TECHNICAL NOTE

PROJECT	:	Land adjacent Sefter School House, Sefter Road, Pagham
NOTE REF.	:	Acl640/21023/TN
NOTE TITLE	:	Additional Information requested by the LLFA
AUTHOR	:	Tafari Lewis
APPROVED	:	Tafari Lewis
DATE	:	11 th March 2022

Scale	1:200 on A1	Drawn	MD
Date	10/03/2022	Checked	TL
File	21-023-Acad-400	Drawing No	21-023-400
		Rev	-

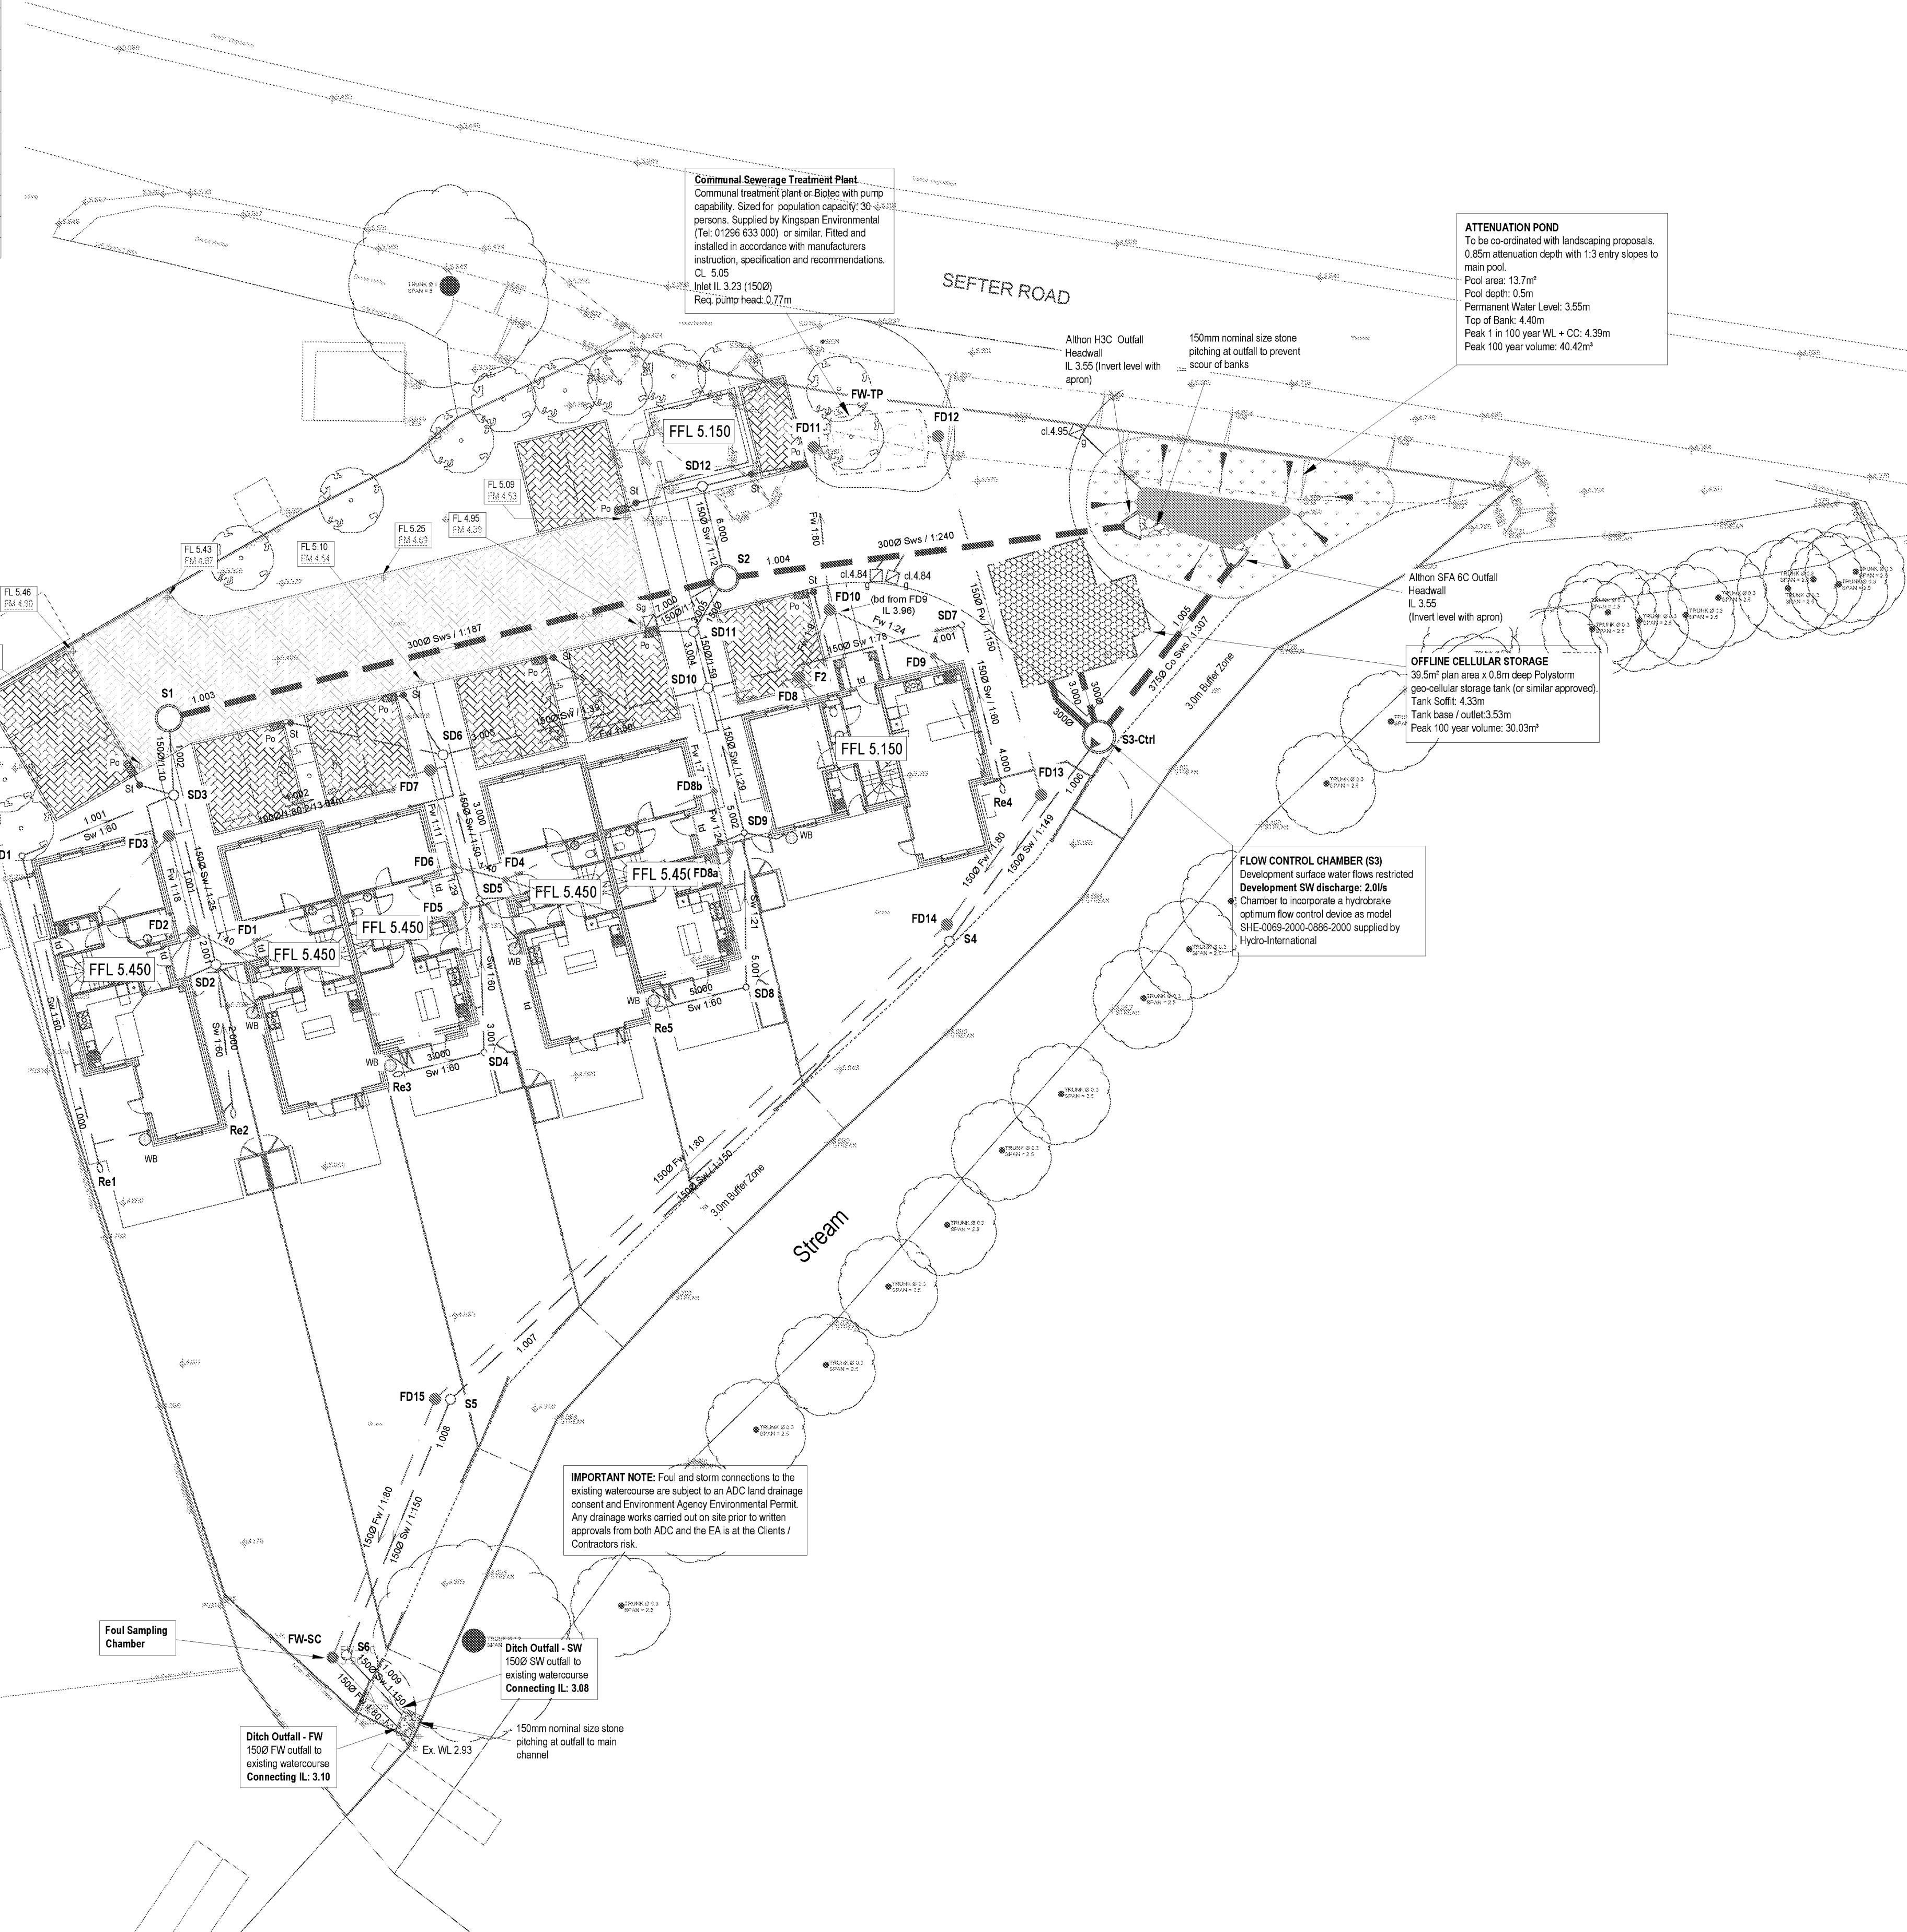
"The proposed invert levels of outfalls are not clear (please clearly define them on plan), however upstream manhole inverts show that outfalls will not meet our minimum requirement for clearance between bed level and invert level of outfall pipes. As an absolute minimum we require 150mm".

"Finish and formation level of permeable paving must be labelled on layout plan".

Finished and formation levels for the main access permeable paving have now been included on the updated drainage layout plan.
